**HUNTINGTON BEACH ENERGY
PROJECT**

Docket No. 12-AFC-02

**AES SOUTHLAND DEVELOPMENT, LLC'S OPENING TESTIMONY,
PRELIMINARY IDENTIFICATION OF CONTESTED ISSUES,
AND WITNESS AND EXHIBITS LISTS; FSA COMMENTS**

June 30, 2014

Topic: **Biological Resources (Noise)**

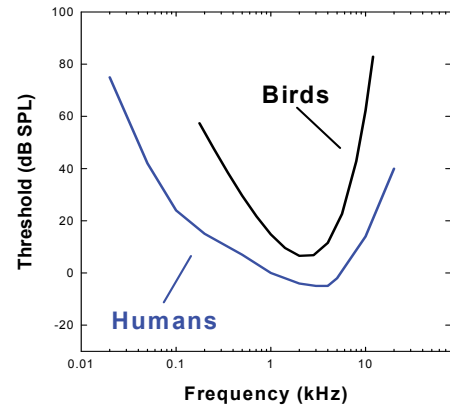
The threshold level of 60 dBA at which anthropogenic noise may interfere with bird communication has been applied in a variety of settings over the past 25 years. As a bird hearing expert I can say that this criterion is a very crude estimate that would only apply in a narrow context in a relatively quiet rural environment without human or traffic activity (the north rim of the Grand Canyon may serve as one example). A precise answer to the question of how interfering any given noise is to birds and their acoustic communication would require information about the level and spectrum of the ambient noise, of the noise in question, and of the bird's vocalizations. This point was made by Dooling and Popper (2007) in a report for the California Department of Transportation (CALTRANS) which reviewed the effects of traffic noise on birds. Since this time, there is now additional evidence suggesting that the 60 dBA threshold is overly conservative when considering the effect of low frequency noise, such as construction noise, on birds. Below I review these previous arguments and provide new information in support of this conclusion.
